# Access Compliance Report

## Public Rights-of-Way

Intersection ID: 22022	Main Street: HAMPTONRIDGE_DR	Cross Street: HEATHSTEAD_PL	Location: NW
ADA ID: BB64272031AD	Ramp Type: PerpDiag	Initial Pass/Fail: Fail	Overall Compliance: No
Codes/Mitigation Info/Possible Solution		Field Measurements/Component Compliance	
Severity Score: 13.75

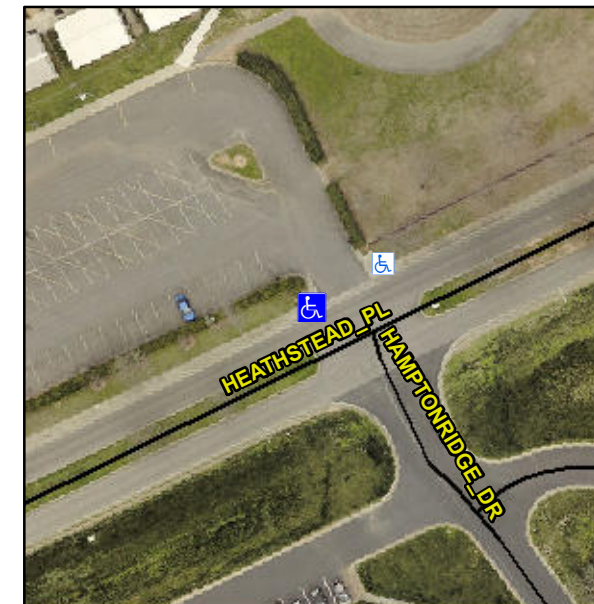
**Not Found, R304.2.2, R304.5.3**

Compliance	Description	Data	Compliance	Description	Data
N/A	Ramp Length (in)	60.0	No	Ramp Slope (%)	10.9
Yes	Ramp Width (in)	48.0	No	Ramp XSlope (%)	3.1
N/A	Flare Type LT	N/A	N/A	Flare Type RT	N/A
N/A	Flare Slope LT (%)	N/A	N/A	Flare Slope RT (%)	N/A
N/A	Flare Traversable LT?	N/A	N/A	Flare Traversable RT?	N/A
N/A	Landing Length (in)	N/A	N/A	DWS Provided?	N/A
N/A	Landing Width (in)	N/A	N/A	DWS Contrast?	N/A
N/A	Landing Slope (%)	N/A	N/A	DWS Length (in)	N/A
N/A	Landing X Slope (%)	N/A	N/A	DWS Full Width?	N/A
N/A	Landing Curb? (Y/N)	N/A	N/A	DWS Offset (in)	N/A
N/A	Shared Landing?	N/A			
N/A	Gutter Ponding?	N/A	N/A	Gutter Slope (%)	N/A
N/A	Gutter Lip Ht (in)	N/A	N/A	Gutter X Slope (%)	N/A
N/A	Painted X Walk1?	No	N/A	Painted X Walk2?	No
	X Walk 1 Direction	To SE		X Walk 2 Direction	To NE
N/A	X Walk 1 Width (in)	N/A	N/A	X Walk 2 Width (in)	N/A
	X Walk 1 Slope (%)	4.8		X Walk 2 Slope (%)	2.6
	X Walk 1 X Slope (%)	1.2		X Walk 2 X Slope (%)	3.9

**Remove & Replace Curb Ramp With Two New Directional Ramps or Equivalent.**
